NOTE: This is an Oscillosaurus panel. The location of the jacks are different from what is shown in the Barton Build Docs

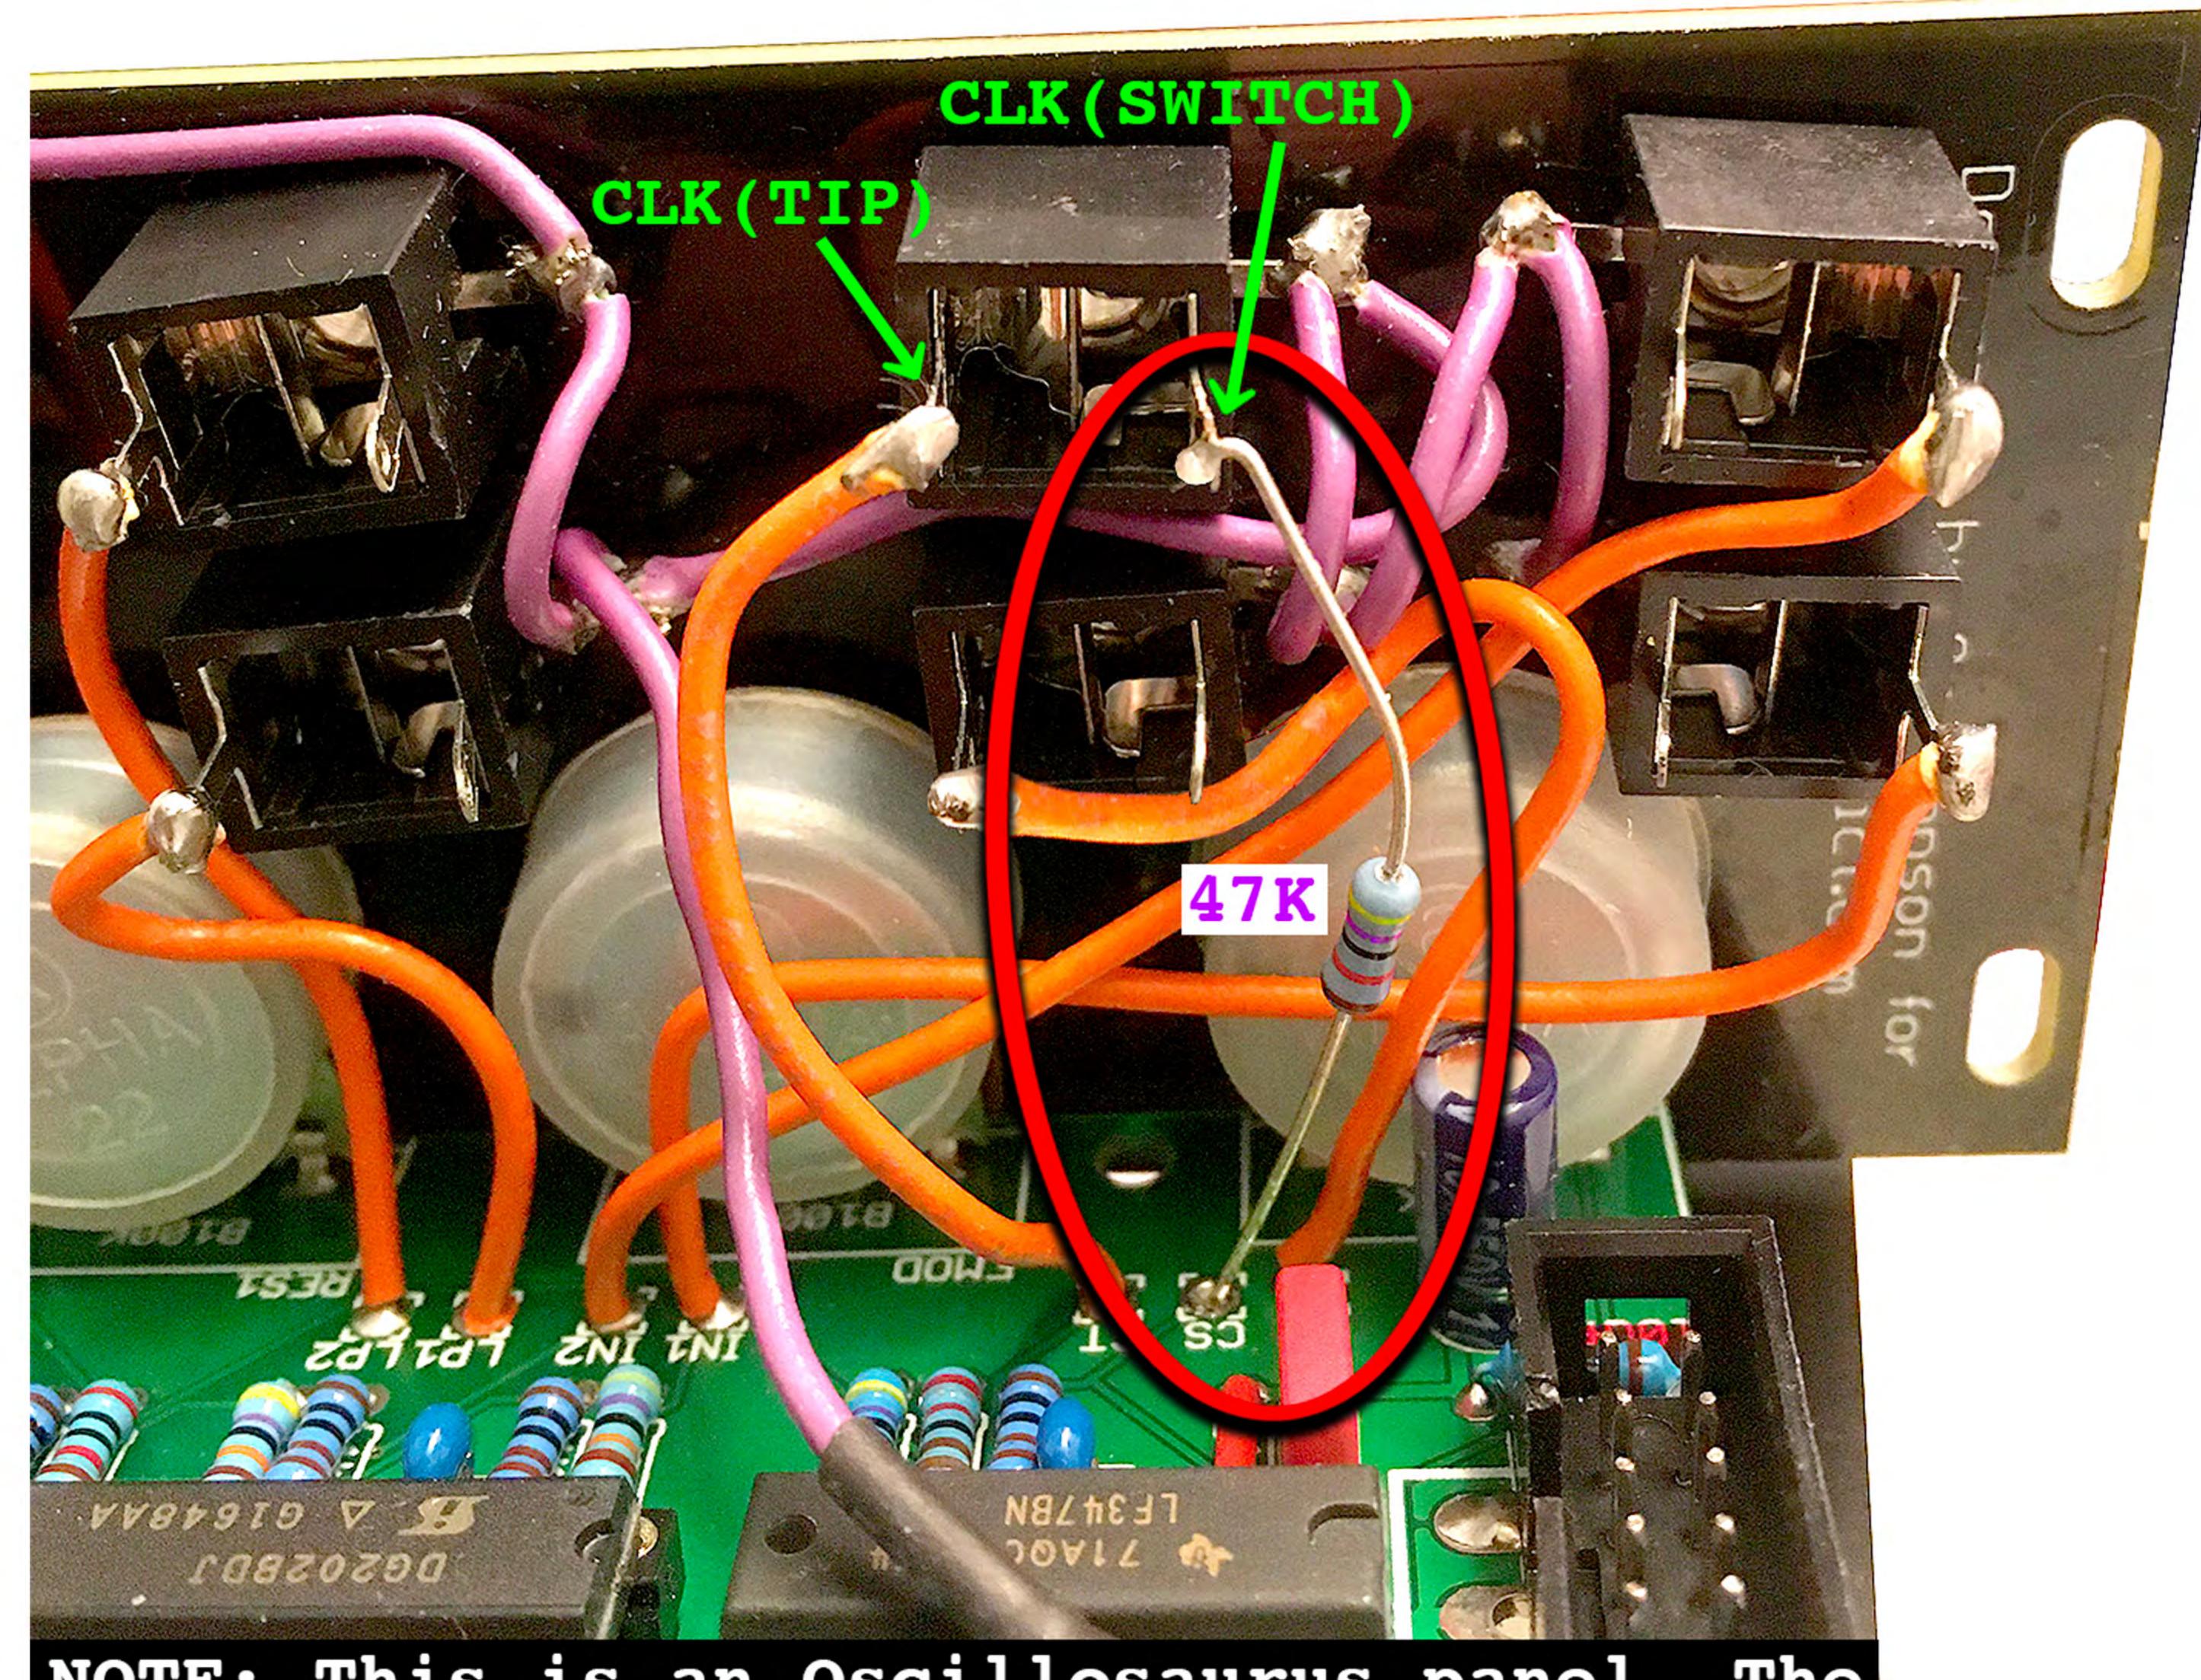
- Remove 4.7K resistor and solder a jumper wire in its place
- (3) Remove wire connecting CS to 3.5mm jack(CLK Switch) & replace with a 47K resistor
